IRON SHIPS.

No. 14022 Survey held at Birkenhead Date Oct 10 1858 to June 25 1857
 on the Ship Edith Byrne Master Hannay
 Tonnage Gross 729 44 Engine Room Register 729 44 Built at Birkenhead
 When Built 1857 By whom built Peto Brassey & Co. Owners A.E. Byrne & Co.
 Port belonging to Liverpool Destined Voyage Calcutta
 If Surveyed Afloat or in Dry Dock Whilst Building, under Special Survey

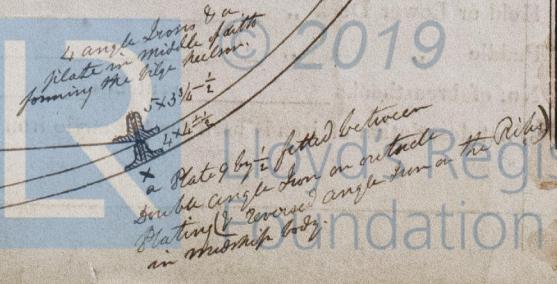
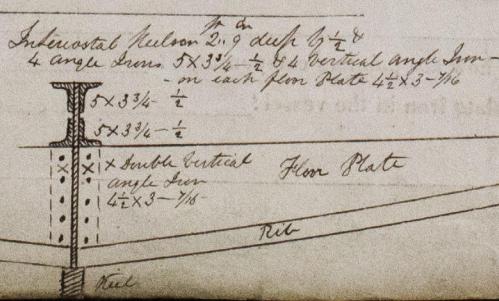
The angle iron on the gunwale plate is less sided & moulded than given by the Rules but is thicker than required & is secured on the outside of the stanchions with the gunwale plate running to the outside of the making strong work. Excepting the Topgallant Forecastle she is a very good vessel in my opinion entitled to the 9 years grade as built for, but respectfully leave the case in the hands of the Committee.

The builders have not adhered to the Rule in the Hold Beam, having a very large one & small one alternately as shown in the sketch on the other side.
